25 March 2020

181210 TAAA

## Forestway Shopping Centre Redevelopment Road Safety Review

Figure 1: Proposed entry/exit intersection (note – signalised pedestrian crossing is existing)

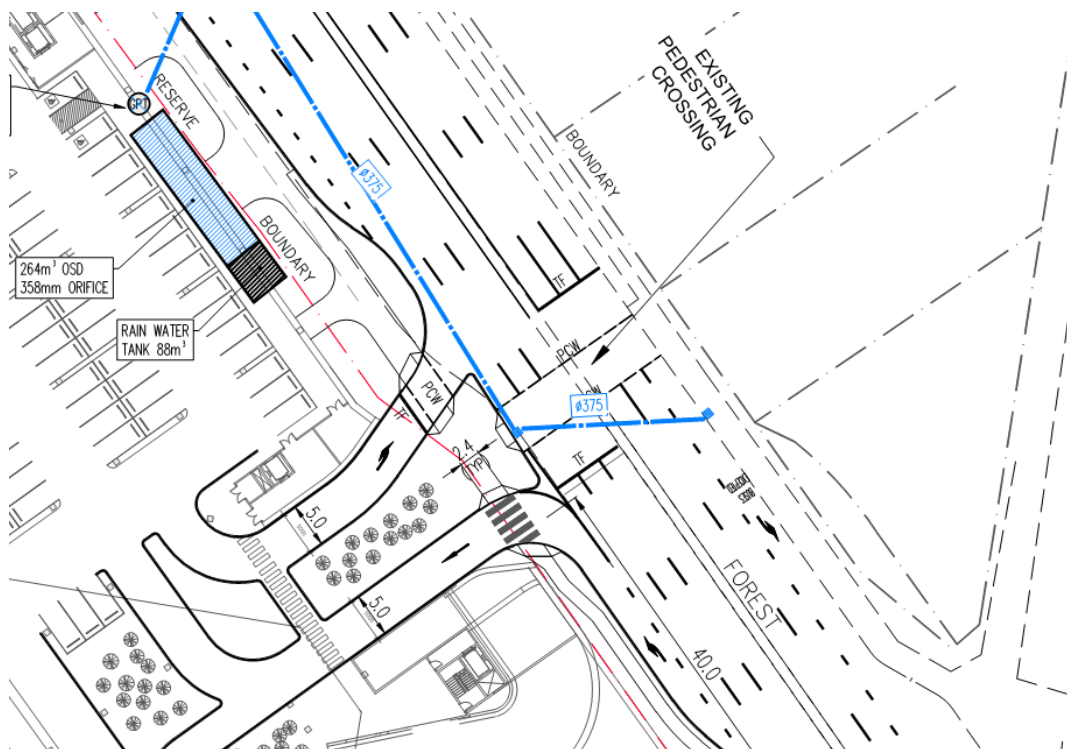
Findings	Recommendations	Suggested Layout	Outcomes (+ see attached)
<p><b><u>1. Inconsistent Crossing Treatments</u></b></p> <p>For pedestrians walking northbound along the frontage of the site, the proposed works would provide a marked pedestrian zebra crossing (at the vehicle entry lane) followed by a signalised pedestrian crossing (at the vehicle exit lane).</p> <p>The differing treatments may be confused by users, – if a pedestrian has right-of-way across one lane, they could assume they have right-of-way across an additional lane immediately following and proceed into an active vehicle lane.</p> <p>This is particularly the case where there is no significant change in road function between the two driveways, in contrast to pedestrians continuing to the crossing at Forest Way where there is a major change in road function</p>	<p>Provide an offset between the two driveway crossings to alert pedestrians to the change in environment and require an active change in behaviour between the two crossings.</p> <p>An example for a mid-block crossing (from the Queensland Department of Transport and Main Roads Supplement to Austroads Guide to Road Design Part 4) is shown below.</p> 		<p>The pedestrian footpath route will be required to be within the road reserve. Movement of the zebra crossing within the site would be outside the road reserve and would interfere with a proposed plant room for the development.</p> <p>As an alternative, an inverse solution is proposed – the zebra crossing can be moved slightly closer to the road, and the signalised crossing further within the site. This proposal also has the added benefit of providing additional pedestrian storage space on the island by increasing the distance between the Forest Way crossing and the driveway crossing.</p>

Findings	Recommendations	Suggested Layout	Outcomes (+ see attached)
<p>and pedestrians may be more alert.</p> <p>It is acknowledged that volumes of pedestrians along the frontage are relatively low and the main development desire line does not follow these crossings, however this risk item carries a high consequence due to potential pedestrian-vehicle collisions.</p>			
<p><b><u>2. Diagonal Shortcuts</u></b></p> <p>Pedestrians cutting diagonally across the road, or rushing for a flashing signal, has been observed at the current site. The provision of the new signalised exit lane on an alternating signal cycle would increase safety risks around this space. Pedestrians cutting diagonally from the crossing westbound toward the northbound bus stop (under a green pedestrian signal) would be crossing the vehicle exit lane (which would also have a green signal). Vehicle volumes exiting the site are likely to be low enough to create inconsistent streams and gaps in traffic, which could give a false impression of a safe gap for pedestrians.</p>	<p>Provide pedestrian fencing along the edge of road reserve (north of the exit driveway lane) to deter pedestrian shortcuts in this area.</p> <p>Provide pedestrian fencing along the road median (consistent with the existing treatment south of the crossing) to further deter pedestrian shortcuts.</p>		<p>An additional pedestrian fence can be incorporated into the design, subject to Transport for NSW concurrence for works on the median of the state road.</p> <p>Completion of these works may also require confirmation of any works related to Northern Beaches Hospital Road Upgrade, which involved replacement of the existing median fence.</p>

Findings	Recommendations	Suggested Layout	Outcomes (+ see attached)
<p><b><u>3. Visibility of Pedestrians at Entry Driveway</u></b></p> <p>The entry driveway requires drivers to give way to pedestrians at a marked pedestrian zebra crossing. Pedestrians travelling northbound would be immediately to the left of approaching vehicles, on the passenger side, at the point of decision for the driver. Visibility to an approaching pedestrian may be difficult and poor, with a potential risk of collision.</p>	<p>Move the zebra crossing further within the site, to provide a more head-on approach to the crossing and a more typical arrangement for all users.</p> <p>Following any changes, ensure pedestrian visibility is maintained around the plant room area such as by a splay or chamfer.</p> <p>This change would also satisfy the recommended offset of crossings.</p>		<p>Due to the proposed offset crossing in Item 1, and other site restrictions, the zebra crossing could not be moved further within the site.</p> <p>It is proposed that zig-zag line marking be provided within the turning lane to alert drivers, plus advance warning signage.</p>

Findings	Recommendations	Suggested Layout	Outcomes (+ see attached)
<p><b><u>4. Width of Entry and Exit Driveways</u></b></p> <p>The entry and exit driveways are each 5 metres wide. This is much wider than would typically be required for single lane car movements, particularly as demonstrated by the swept path analysis for B99 vehicles. The excess width may encourage higher-than-normal vehicle speeds through these spaces, which could pose a hazard for pedestrians.</p> <p>Requirement for larger vehicles such as delivery and service vehicles is not shown in the swept path drawings.</p>	<p>Reduce the lane width at both the entry and exit driveway to act as a traffic calming measure and slow vehicles in areas with pedestrian interaction.</p> <p>This change would also increase physical clearances to walls adjacent to each driveway.</p>		<p>The lane width can be reduced within the site. The lane width at the corners is suggested to be retained at the current design width.</p> <p>Lane width within the deceleration is also already low (3.0m) which should assist in traffic calming.</p>

<p><b><u>5. Pedestrian Vulnerability to Errant Vehicles</u></b></p> <p>The deceleration lane at the entry driveway ends in a tight left-hand turn into the site. In the event of an errant vehicle being unable to make this turn, the vehicle would travel directly onto the pedestrian island in front of the signalised crossing, which is a designated waiting and queuing space for pedestrians.</p>	<p>Provide a vehicle crash barrier at the pedestrian island, to protect pedestrians waiting at the signalised crossing.</p> <p>Reduction in lane width (as recommended above) would act as a traffic calming measure which would also help to improve pedestrian vulnerability risks.</p>		<p>An F-type concrete barrier could be provided at this location, subject to detailed design and finalisation of the pedestrian crossing location.</p>
